Sent: 24/08/2021 7:02:23 AM
Subject: DA2021/1032 - 8 Delecta Avenue CLAREVILLE
Attachments: G & S Coops submission 2.pdf; David Tory Architect's report.pdf;

DA2021/1032, Lot 20 DP 13291
8 Delecta Avenue, Clareville

OBJECTION TO DEVELOPMENT APPLICATION DA2021/1032

Alterations and Additions to a dwelling House
at Lot 20 in DP 13291
8 Delecta Avenue
Clareville NSW 2107

Image A: Model of Proposed Site Development

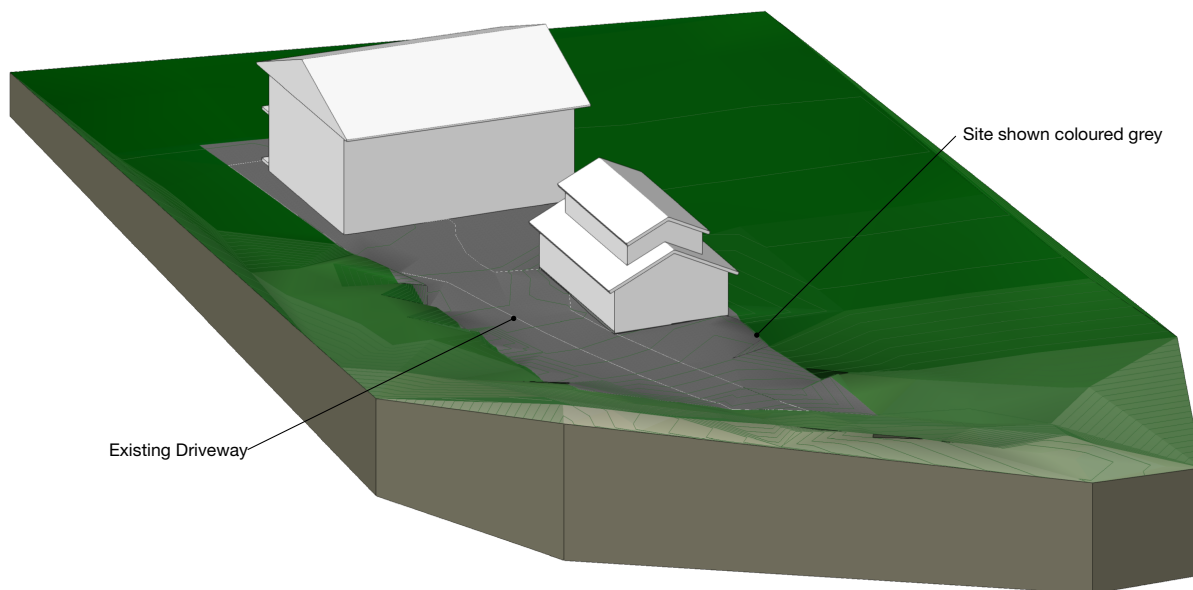
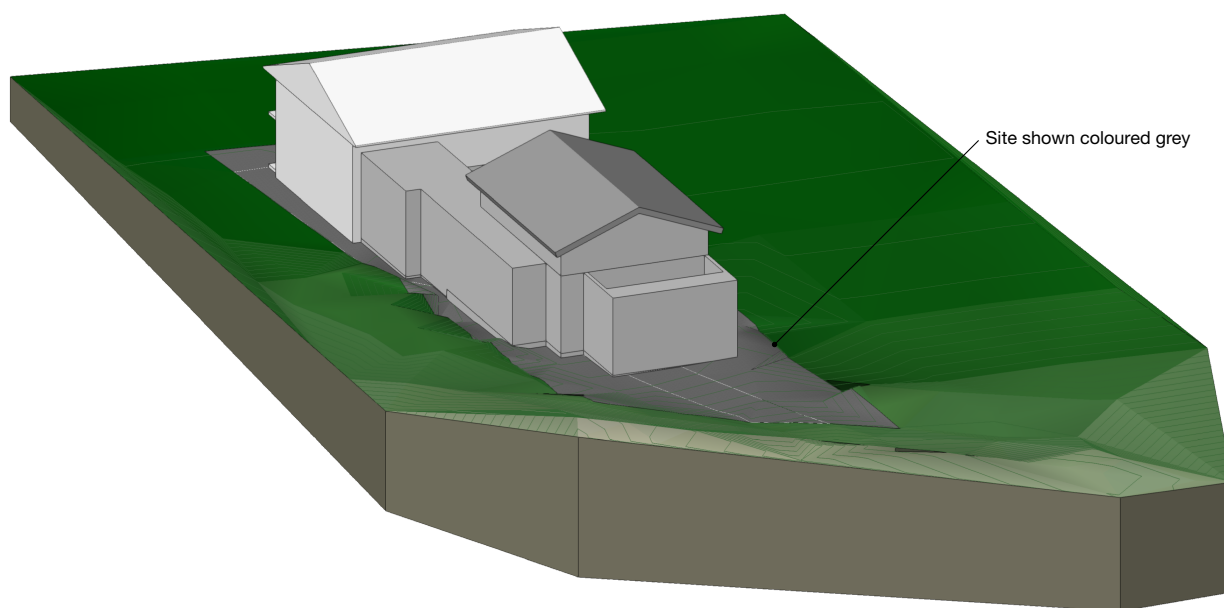
The comparison in the DA between the existing and the proposed development is misleading and specious. This is graphically shown in the following two images.

According to the DA calculations expressed in table 1, Image A has a landscaped area of 47.08% of the site whereas image B has a landscaped area of 52.5% of the site.

Where Landscape Area is a control of Bulk and Scale the figures mentioned in the DA are specious and misleading.

It is clear that Image A has a large area of open space around the buildings, the buildings are of low bulk and scale, and there is the potential for much green landscaping. Image B, on the other hand, has a small amount of open space around a building with a high level of bulk and scale, with a limited opportunity for green landscaping.

Yet the DA states that Image B has more Landscape Area, and consequently less bulk and scale, than Image A. Clearly that is not actually correct.

The Respondents object to the inclusion of the roof garden in the Landscape Area, and to the implementation of wheel strips in the landscape Area equation, and believe that the proposal should conform to Part D1.14, of the DCP, and require the development to provide a minimum 60% of the site area as landscaped area.

G: ROOF GARDEN:

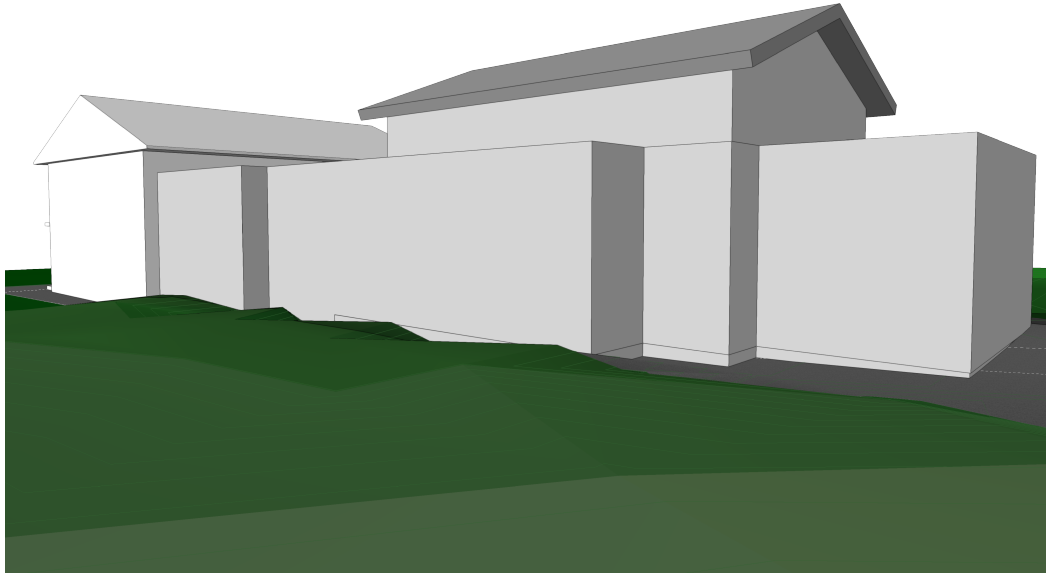
The single story brick and concrete green roof structure has an average height of 4.5 metres above natural ground level. This results from a 3.2 metre ceiling height (to part), and a 1 metre soil depth above. It is proposed to be built on the south western side of the alterations and additions, close and adjacent to the shared boundary with the house at No 6 Delecta Avenue.

The western end of the green roof joins to the eastern wall of the existing house on the site, and extends south east to the proposed front door. Here it joins the south western brick wall of the proposed garage which has the same height. The resulting combined new and existing brick wall is approximately 34 metres long.

The Respondents believe that the bulk and scale of the green roof structure is unnecessary and that it could be replaced with a lower, lighter weight structure with metal roof, located further away from the boundary, with more varied modulation to its edge and fenestration, and a marked reduction in bulk and scale. This structure could be located further away from the Melaleuca , with a lighter floor structure and footing system that would allow the tree to remain. A lower structure would also allow the branches of the tree to remain in place.

OVERALL VIEW OF SW WALL OF PROPOSED HOUSE

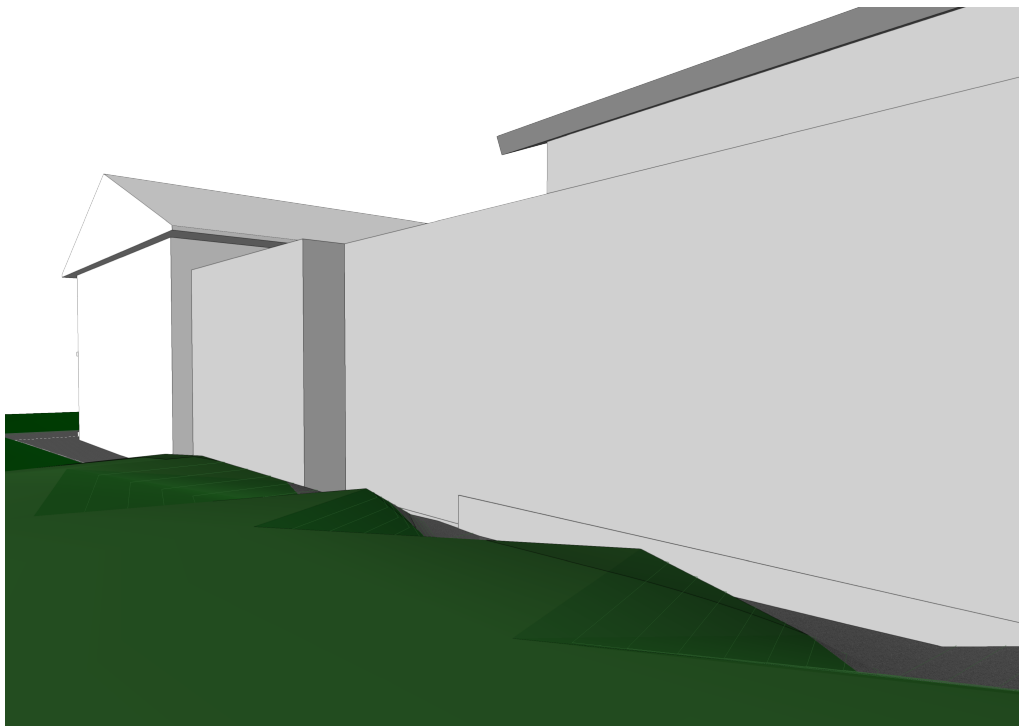
The Respondents believe the length and height of this brick expanse is out of scale with the house at No. 6 Delecta Avenue. This neighbouring house has been designed in the following manner:

In comparison, the length and height of the south western wall of the proposal is a relatively massive proposed structure. It does not acknowledge the good neighbourliness of the house at No. 6, or pay heed to the maintenance of the canopy tree which the owner's of No. 6 Delecta Avenue worked hard to preserve.

The Respondents do not understand why this building element is so massive, out of scale, and out of context with its surroundings.

EXISTING LANDSCAPE AREA

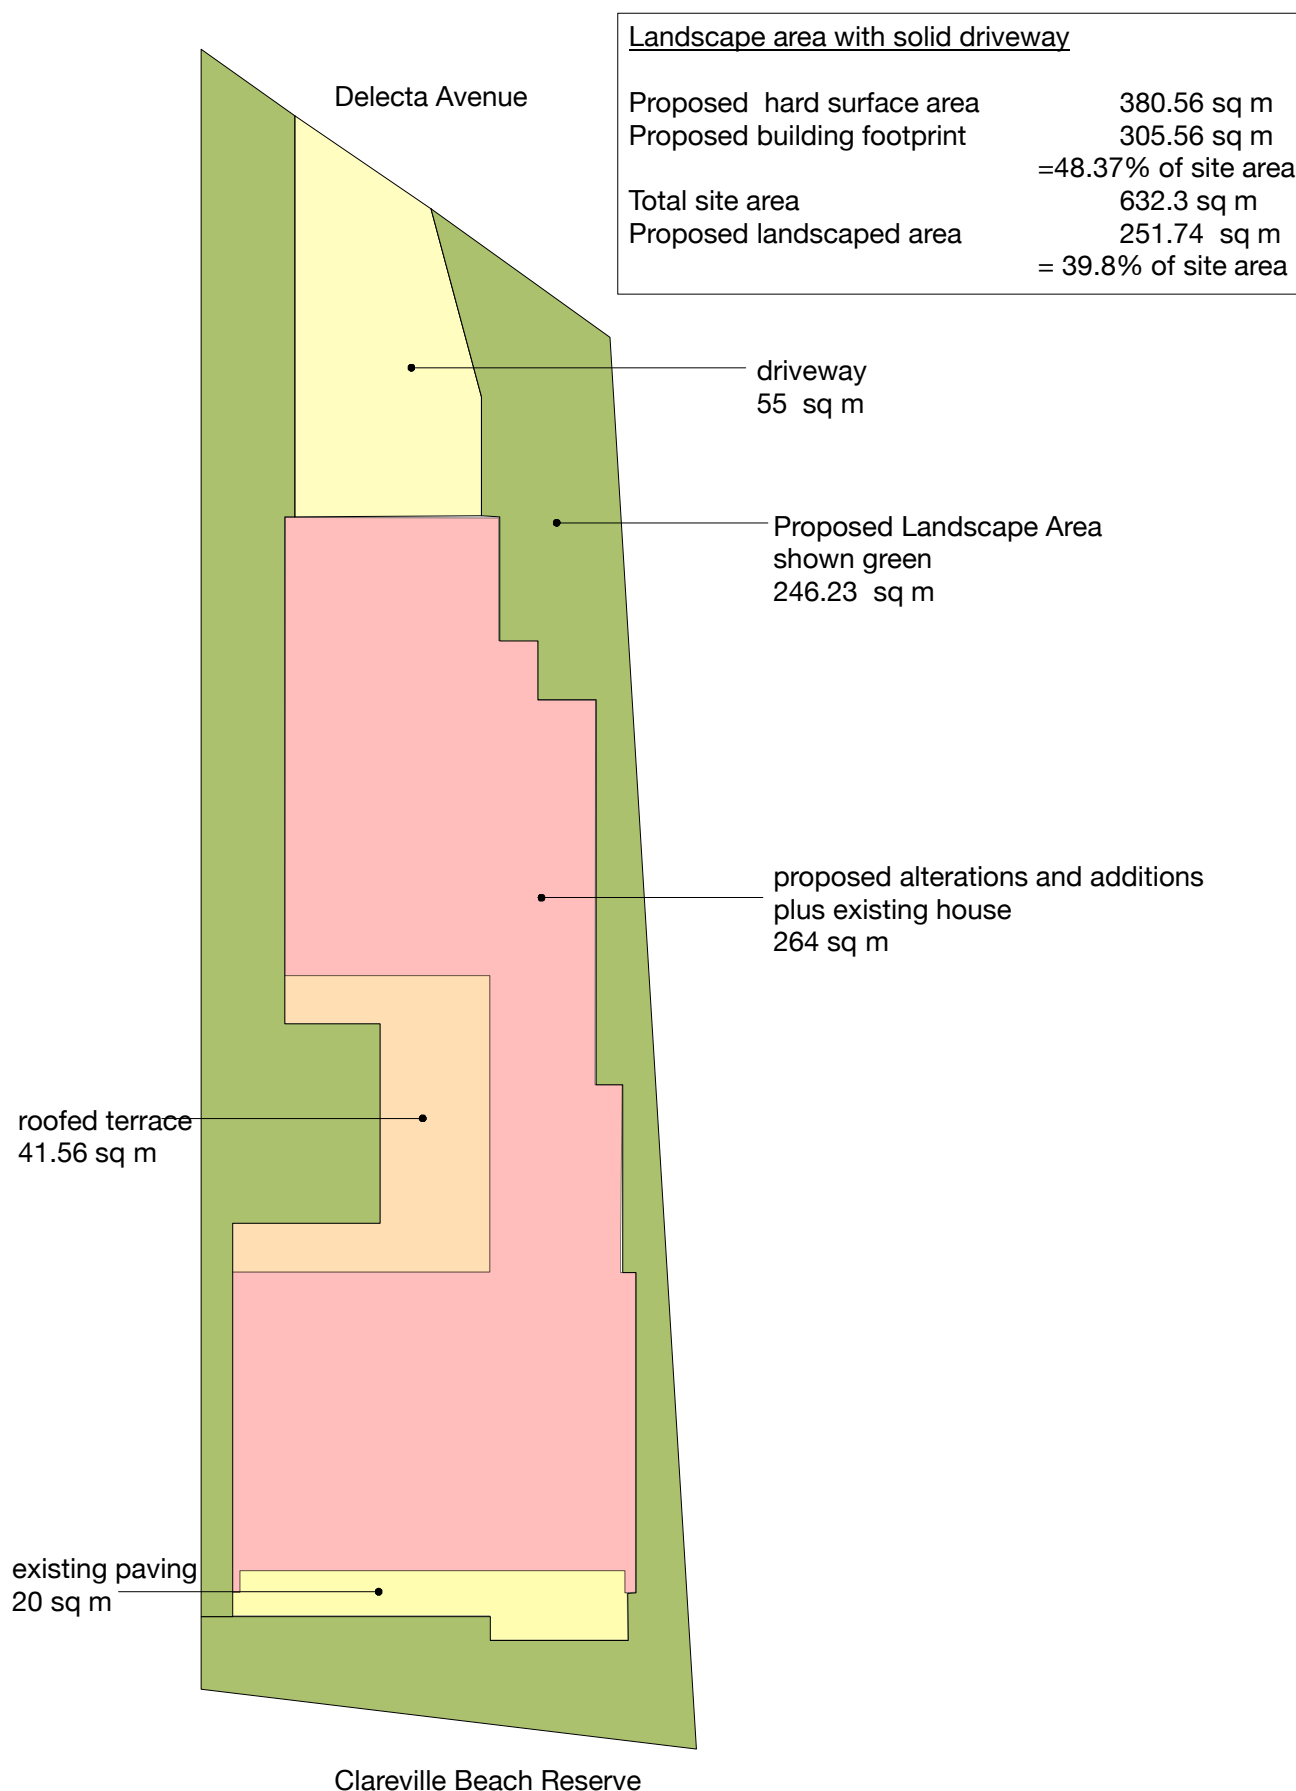
Existing hard surface area	314.76 sq m
Existing Building Footprint	172.49 sq m
	27.28% of site area
Total site area	632.3 sq m
Existing landscaped area	317.54 sq m
	50.2% of site area

PROPOSED LANDSCAPE AREA
(with complying driveway)

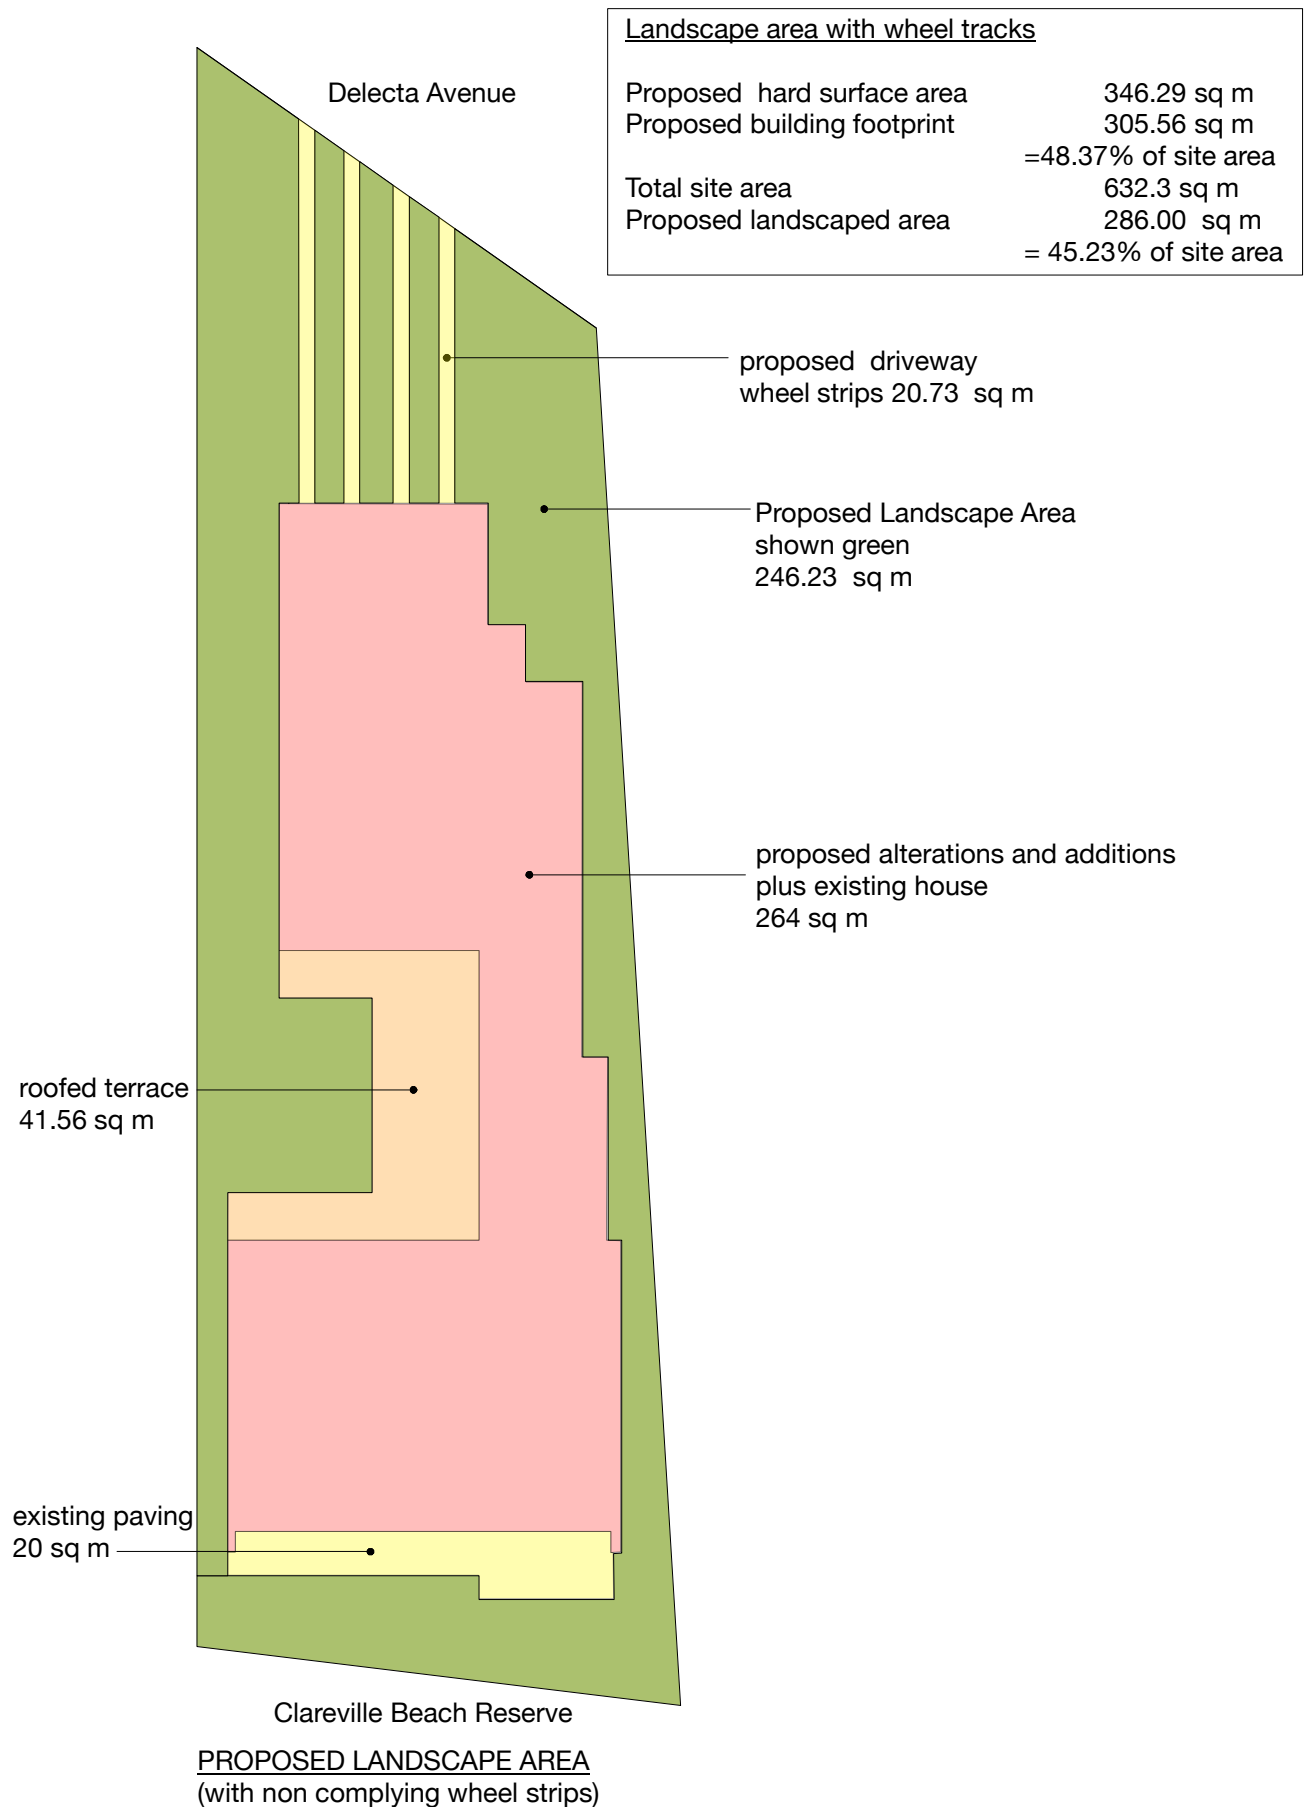
The Landscape Area calculations for this report do not include the proposed roof garden as Landscaped Area, as this is not a provision of the DCP as mentioned in D2 above. The calculations in this report include the area of a full driveway in lieu of the wheel strips for the reasons mentioned later in Part E.

Landscape Area Calculations in this report		Landscape Area Calculations in the DA	
	Existing Site	Proposed Development	Existing Site	Proposed Development
Site Area	632.3 sq m	632.3 sq m	632.3 sq m	632.3 sq m
Hard Surface Area	314.76 sq m	380.56 sq m	334.60 sq m	300.10 sq m
Hard Surface Area Percentage	49.8%	60.2%		
Landscape Area	317.54 sq m	251.74 sq m	297.70 sq m	332.20 sq m
Landscape Area Percentage	50.2%	39.80%	47.08%	52.54%

That the proposal is re-visited and re-submitted in a form where the Landscape Area is 60% of the site area, measured in accordance with the provisions of the DCP, without a roof garden being counted as Landscape Area, and with a complying driveway included in the design calculations.
